STAFF REPORT: NOVEMBER 12, 2025 REGULAR MEETING

APPLICATION NUMBER: HDC2025-00655

ADDRESS: 1613 LEVERETTE STREET

SCOPE: DEMOLISH GARAGE, ERECT CARRIAGE HOUSE

Elevation drawings for proposed carriage house, submitted by applicant.

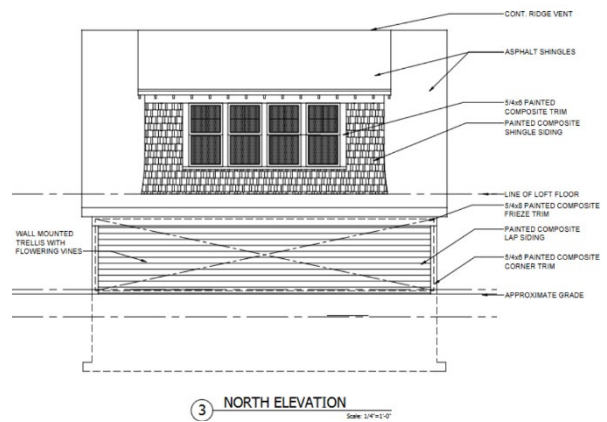
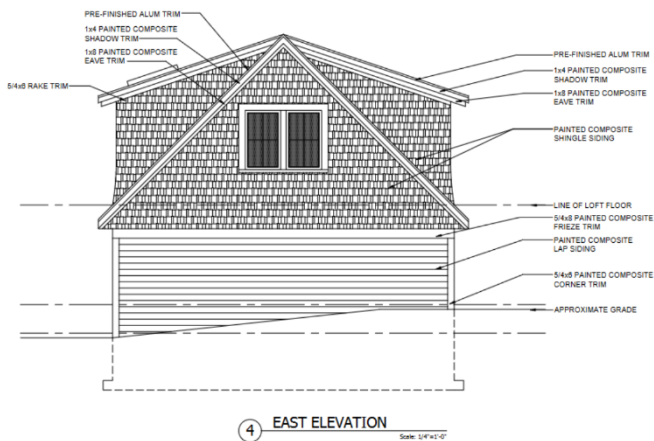
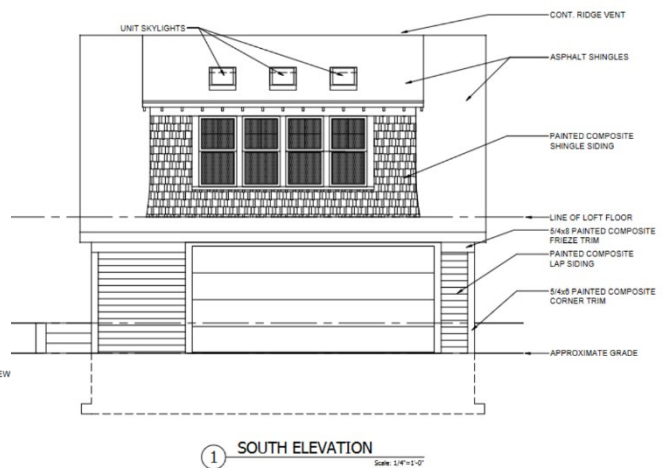
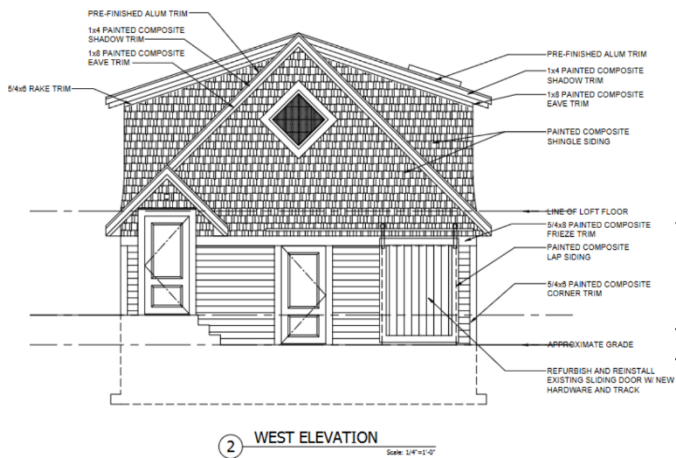
- It is staff's opinion that **the proposed garage design generally appears to be compatible within the existing context**. Its use of the horizontal lapped composite siding on the first level blends well with the neighboring alleyway garages. The added height matches reasonably with the context of the historic house and the property's nearby historic surrounds.

Photos provided by applicant, shows interior condition of the existing garage

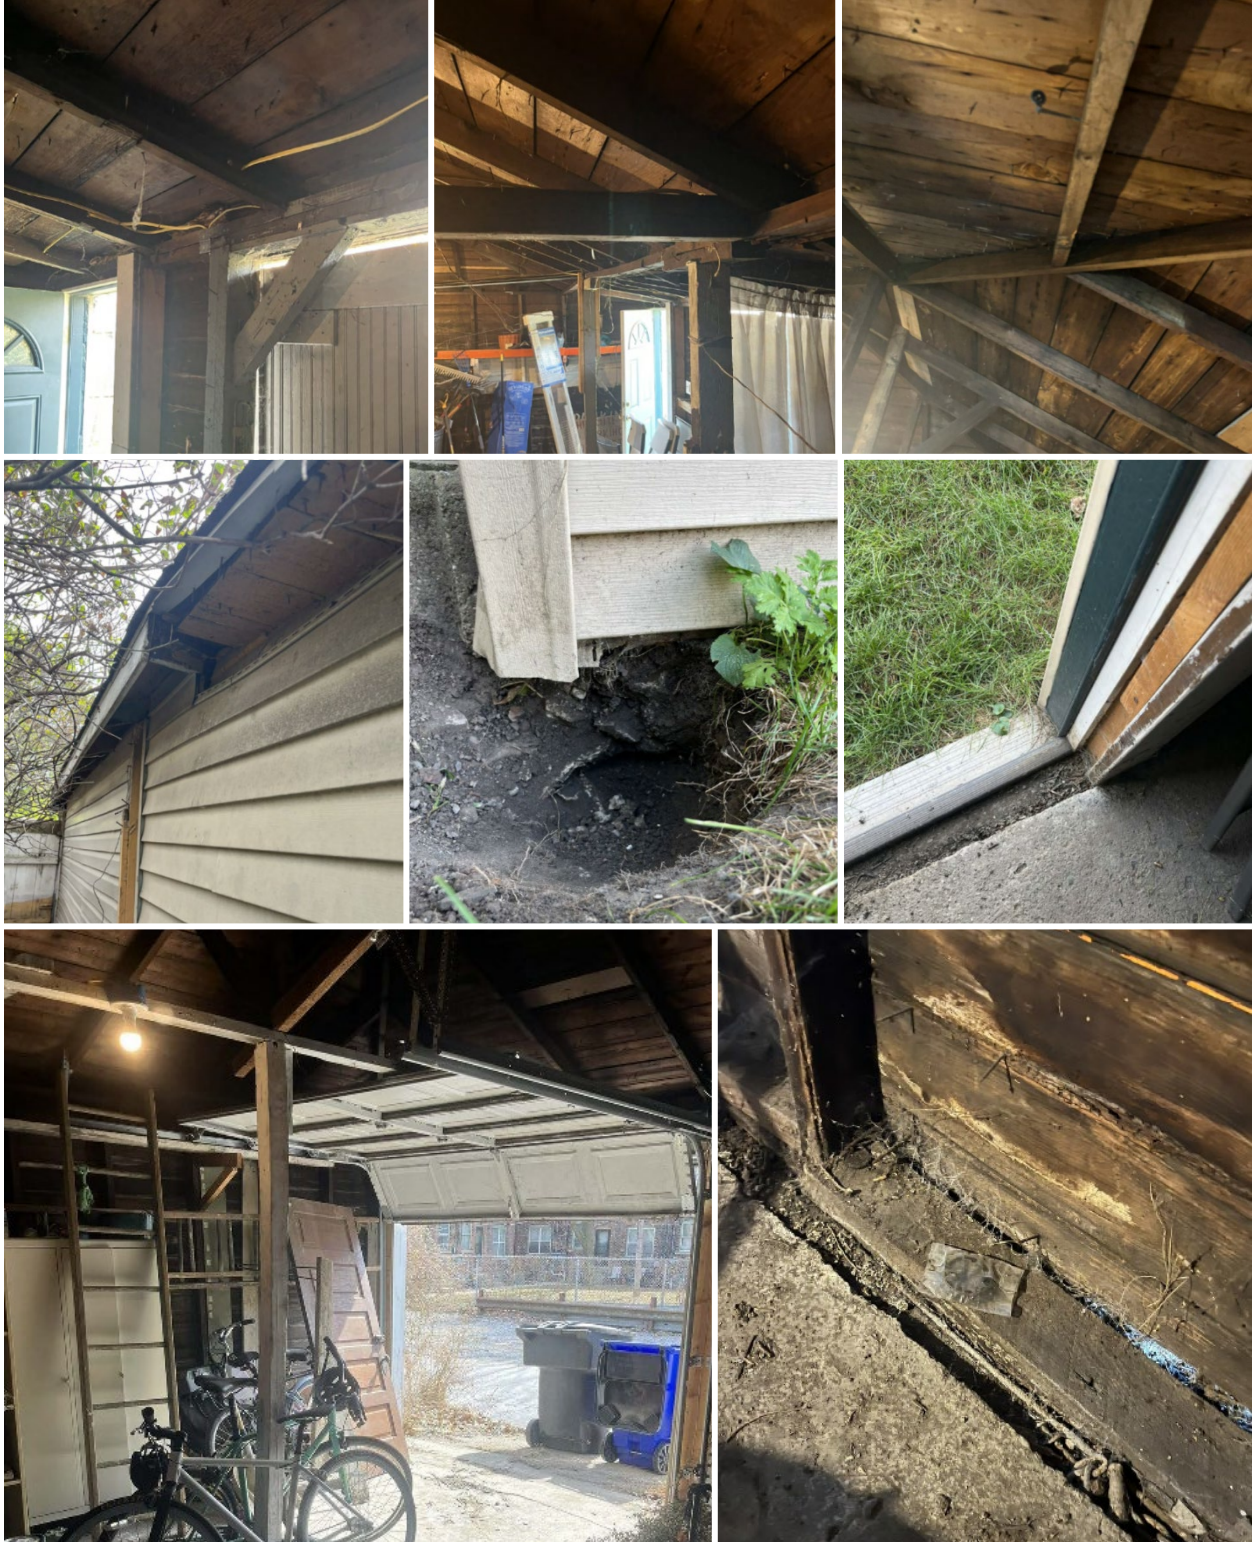
- **Exterior Walls:** The architect assesses the condition of the exterior walls as poor. Sill plates did not appear to be anchored to the foundation (though this can be remedied), but

approximately half of the sill plates are rotting and deteriorated. Additionally, sill plates were up-heaving in one corner. Most critically, in staff architect's opinion, the west wall is 8" out of plumb and leaning toward the south. The other three walls are between 2-4" out of plumb. At least one wall would need to be completely rebuilt. It is doubtful that the current racked structure could reasonably endure a partial rebuild.

- **Roof:** The architect also assesses the condition of the roof as poor. Creditable deficiencies include the overloading of the roof's lightly built original structure, which has suffered substantial deflection and failure in the roof structure to the point that additional support is clearly necessary and present in the form of a temporary column. Though this could have been caught earlier and reinforced, the opportunity for such a remedy has clearly passed and the roof needs to be rebuilt.

- **Foundation:** Differential settlement of original slab, no evidence of footings. Deficiencies observed include cracking, separation, and spalling.
- The architect additionally notes the interdependency of the roof, wall, and foundation systems, which complicates any good faith repair effort.

- Based on the above observed deficiencies, and without accepting arguments that historic structures must be held to modern code standards, staff architects assess that the garage is beyond reasonable repair, as repair would in effect require a complete rebuild, eliminating most of the building's historic integrity, or else require an unreasonably complex and surgical historic preservation treatment exceeding the structure's apparent economic, architectural, and historic value.
